CITY PLANNING COMMISSION

- APPLICATION:**
- A. Negative Declaration
 - B. Special Permit to locate 15 of 51 required parking spaces in the Single Family Residential (R-1) zone (Section 2-C-28)
 - C. Variance to locate 15 required parking spaces off-site (Section 6-A-11)

LOCATION: 2516 Stockton Boulevard

PROPOSAL: The applicant is requesting the necessary entitlements to develop a medical office facility.

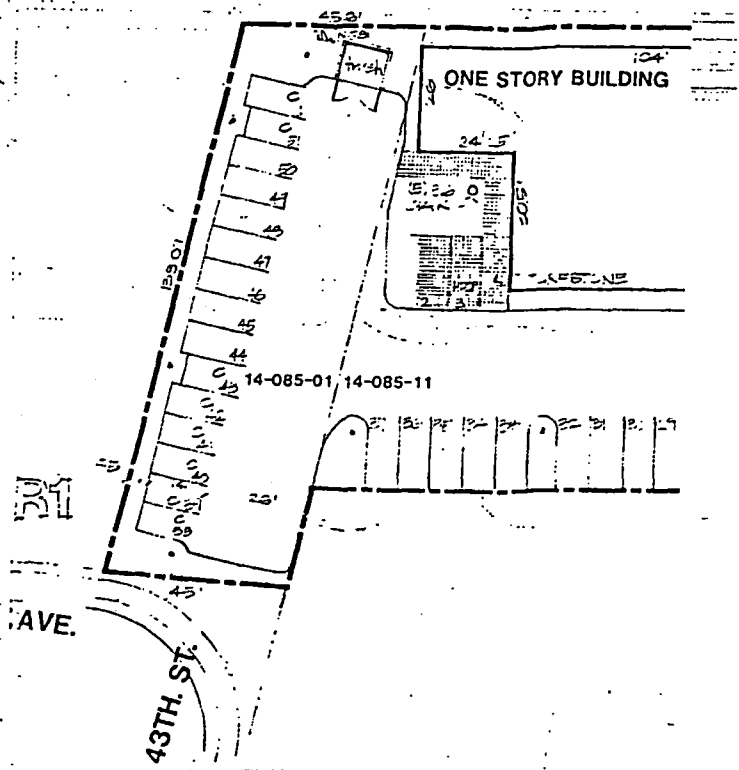
- C. The site plan indicates that a trash enclosure will be located on the northwest side of the site. As shown, the trash enclosure encroaches into the five foot side yard setback. The proposed enclosure will, therefore, be required to be relocated out of the setback area. Staff also recommends that a solid masonry wall be placed around the trash container and that closeable metal doors be provided on the enclosure. Detailed plans and elevations of the enclosure should be submitted to staff for review and approval prior to issuance of a building permit.

- E. The applicant's plans were reviewed by the City Arborist since a large healthy Oak tree is located on the site. The applicant is proposing to incorporate the Oak tree into the on-site landscaping. In an effort to preserve the tree the paved area around the tree will consist of turfstone. The City Arborist indicated that adequate clearance was provided for the Oak but that no grade changes should occur within the dripline of the Oak tree.

2. Detailed plans and elevations of the trash enclosure shall be submitted to staff for review and approval prior to issuance of a building permit. The location of the trash enclosure shall be outside of the five foot side yard setback area. The trash receptacle shall be enclosed by a solid masonry wall with closeable metal doors.

3. No grade changes shall occur in the dripline of the existing Oak tree. Final site grading and improvement plans shall be submitted to the City Arborist for approval prior to issuance of a building permit.
